Monitoring Report – MY4  
FINAL VERSION  
Lake Wendell Mitigation Project  
Calendar Year of Data Collection: 2021

NCDEQ DMS Project Identification # 97081  
NCDEQ DMS Contract # 6826  
Neuse River Basin (Cataloging Unit 03020201)  
USACE Action ID Number: SAW-2016-00876  
NCDEQ DWR Project # 2016-0385 V2  
Johnston County, NC  
Contracted Under RFP # 16-006477  
Data Collection Period: September 2021  
Submission Date: October 20<sup>th</sup>, 2021

**RE: WLS Responses to NCDEQ DMS Review Comments for Task 10 Draft Monitoring Report Year 4 for the Lake Wendell Mitigation Project, NCDEQ DMS Full-Delivery Project ID #97081, Contract #6826, Neuse River Basin, Cataloging Unit 03020201, Johnston County, NC**

**Figure 5: Monthly Rainfall Data**  
**Lake Wendell Mitigation Project (NCDEQ DMS Project ID# 97081)**  
**MY4 2021**

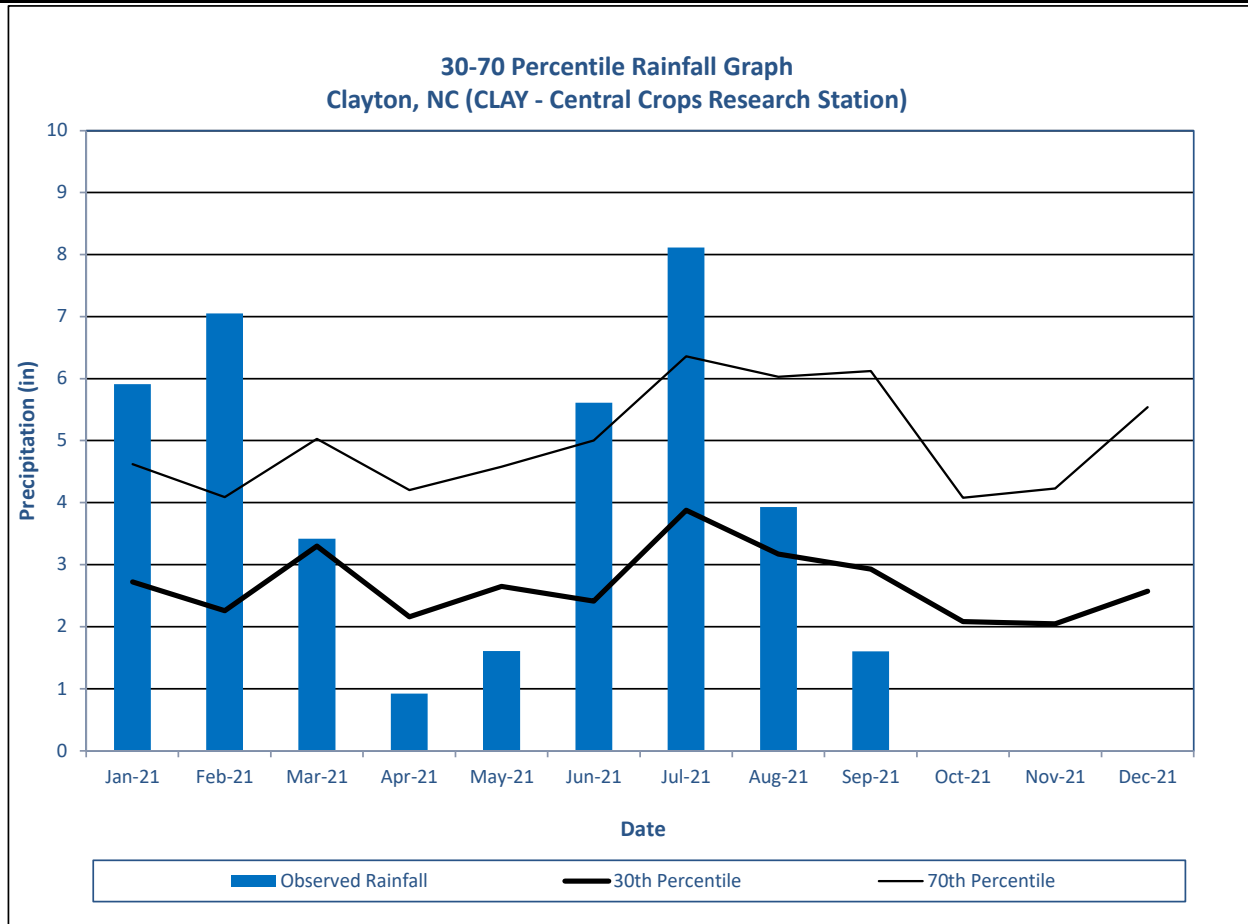
- 4. DMS Comment: Update rain report for additional months if possible.** WLS Response: September rainfall data was added to Figure 5.
